Oakfield Wind Project // Oakfield, Maine
 Evergreen Wind Power II, LLC, applicant
 Site Location and NRPA

Additional Excerpts from Department Record

482	Letter from Brian Raynes, re: comments on application	May 12, 2009
487	Wind Turbine Neuro-Acoustical Issues By Dora Mills, MD, MPH Maine CDC/DHHS	June 2009
493	Email from Brian Raynes, re: comments on application, with attachments	July 19, 2009
521	Letter from Juliet Browne, re: Town of Oakfield, with attachments	September 15, 2009
529	Letter from Rufus Brown, re: Report of Rick James, with attachment	October 16, 2009
551	Letter from Juliet Browne, re: noise easements, with attachments	November 2, 2009
559	Letter from Juliet Browne, re: response to comments, with attachments	November 2, 2009
635	Response to Powers Trust Objection, from Resource Systems Engineering, re: noise issues, with attachments	November 3, 2009
787	Email from Dora Mills, re: Health Effects	November 30, 2009
789	Letter from Phillip Powers, re: response to applicant's response, with attachment	December 1, 2009
793	Email from Warren Brown, re: comments on noise	December 17, 2009

Figure 1-Project Area Showing Noise Contours

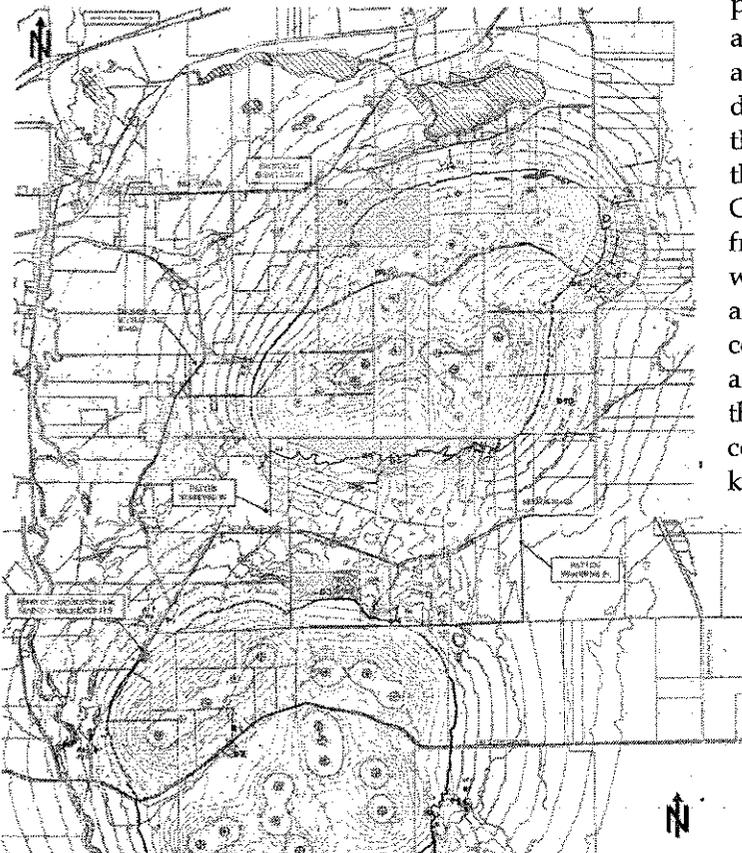
The Oakfield Wind project will result in nine (9) of residences (Sites R1 to R9 in Figure 1) that have not signed easements (ten (10)) being within 1860 and 2690 feet of one of more wind turbines. Figure 1 illustrates the extent to which the proposed footprint of the wind utility will encroach on residential homes. According to Table 3 of the RSE Noise Study people in these homes will be exposed to sound levels of 42 to 45 dBA on a regular basis day and night. In the Sound and Noise section of the Wind Energy Committee report (page 13, section II.A.1) it is noted that for research relating wind turbine sounds in dBA and annoyance (WindFarm-Perception Study) finds that at or over 45 dBA 28% or 1 out of every 3 to 4 people will be "very annoyed." This is a best case estimate of annoyance since it is based on the RSE model's predictions which this reviewer believes are flawed and understate the sound levels that will be frequently present at those homes.

Figure 3-Vestas V-52 Spectrum (From NREL)

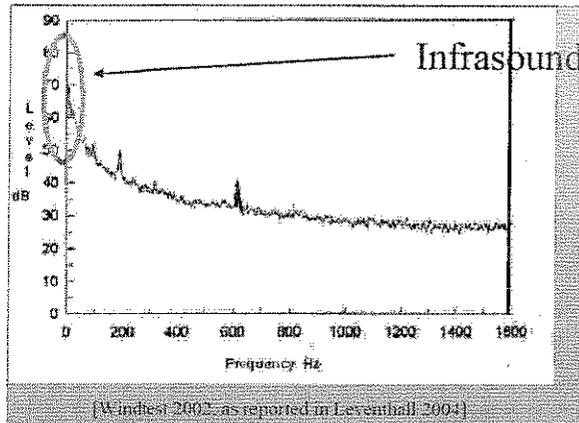
Figure 3, the wind turbine spectrum for a Vestas V-52, shows some of the same spectral characteristics. It does not show the tones and harmonics at the blade passage frequency (BPF) because for industrial scale upwind turbines this is usually between 1 and 2 Hz and the harmonics occur usually below 10 Hz. Because this is a difficult range of frequencies to measure, especially in field test situations, most information about the spectral characteristics do not show the infrasound range (0-20Hz) sound pressure levels (SPL). This is further obscured by the practice of wind industry acoustical consultants to present data using of A-weighting (dBA). The practice masks the spectrum shape by creating a visual impression of minimal low-frequency sound content. Even when octave band (1/1 or 1/3) SPLs are presented the reports normally ignore frequencies below 31.5 or 63 Hz. The wind industry and its

Figure 4-Wind Turbine Infrasound

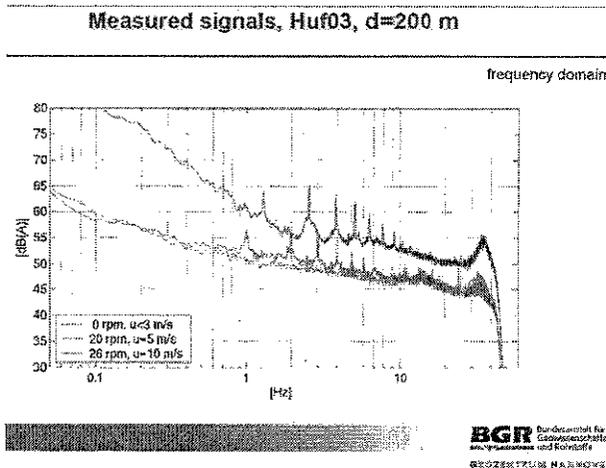
The graphic to the left (Figure 4) is expanded in the lower frequency range to show a wind turbine's spectrum for the frequency range of 0-10 Hz. Now the tones and harmonics are clearer. Also note the correlation of the frequency of the tones to rotational speed. This graph is from a study conducted by the Federal Institute for Geosciences and Natural Resources,

Figure 5-Sound Power Level of 37 Turbines Normalized to 1MW

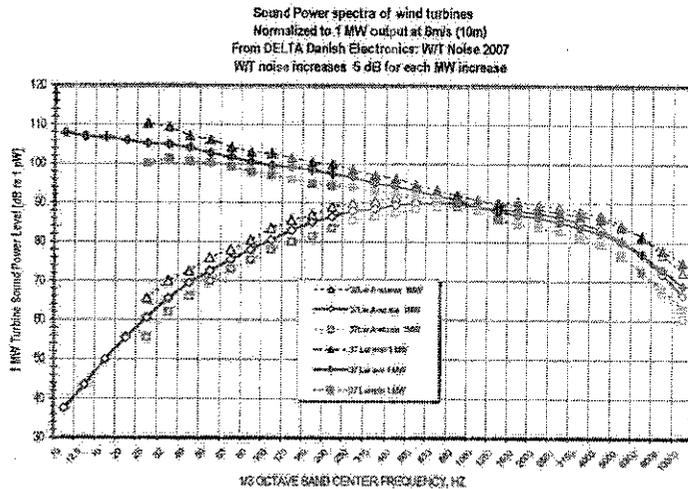
Are the sound emission characteristics similar or different for different models and makes of wind turbines? Figure 5 shows the general spectrum shape of 37 modern upwind turbines of the type and sizes being located in the Oakfield. This graph shows the sound power data after normalizing the data for each turbine to 1 MW of power output.² It is clear that there is little deviation in spectral shape between any of the various models

Figure 6-Audible Blade Swish inside home from New York Wind Utility

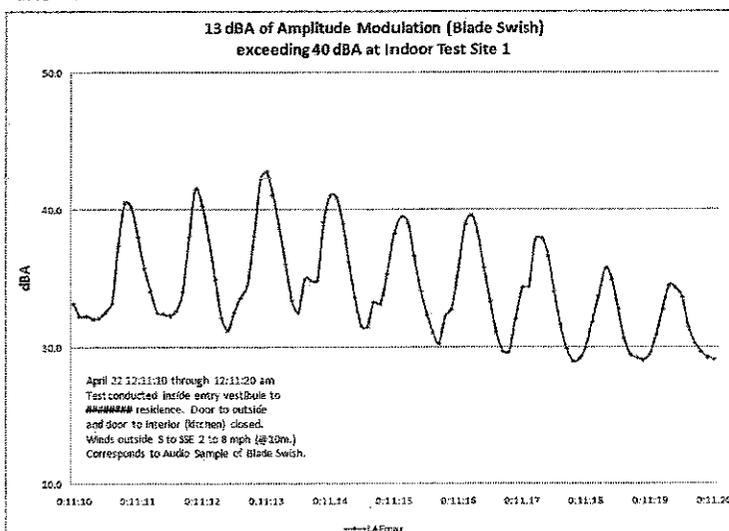
This author has confirmed amplitude modulation (blade swish) at every wind project he has investigated. During periods of high turbulence he has measured levels of blade swish of 10-13 dBA. Figure 6's graph shows the rise and fall of the A-weighted sound levels from blade swish measured inside a closed entry vestibule to a home. This test site is approximately 1500 feet from two (2) turbines with sound emission characteristics similar to the turbines proposed for the Evergreen Wind Power II, LLC, project. It should be noted that other tests measured sound levels exceeding 40 dBA inside the home in the rooms facing the turbines with a window partly open.

Figure 7-Chart showing range of sound levels at one Mars Hill test site from four quarterly sound studies

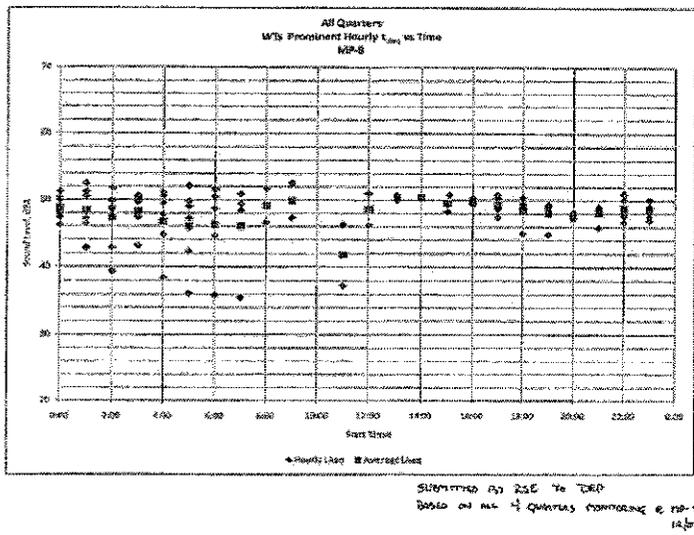
understand this variability visually. The chart in Figure 7, was presented to the citizens of Mars Hill, Maine in December of 2008 by the Director of the Maine Bureau of Land and Water Quality which includes the Dept. of Environmental Protection. Maine's MDEP had commissioned a four quarter study of the sound levels under various operating conditions and seasonal variations that was conducted by RSE. This chart shows the 'best' of the data that was hand selected to represent only sound levels when wind turbines were operating and clearly audible. The test site is over 2000 feet from the nearest wind turbine, a 1.5MW upwind model. Note that the sound levels range from a low of about 35 dBA to a high of just over 52 dBA. All of these represent wind turbine sounds and not wind or other artifacts. The initial model estimated that the sound levels at this site would be 47.5 dBA. This is about 5 dBA lower than the highest level in the MDEP chart and 12 dB over the lowest level which was identified as wind turbine sound. Sound levels higher than 52 dBA were observed, but not included on the chart because winds prevented accurate measurement of the turbines as separate noise source.
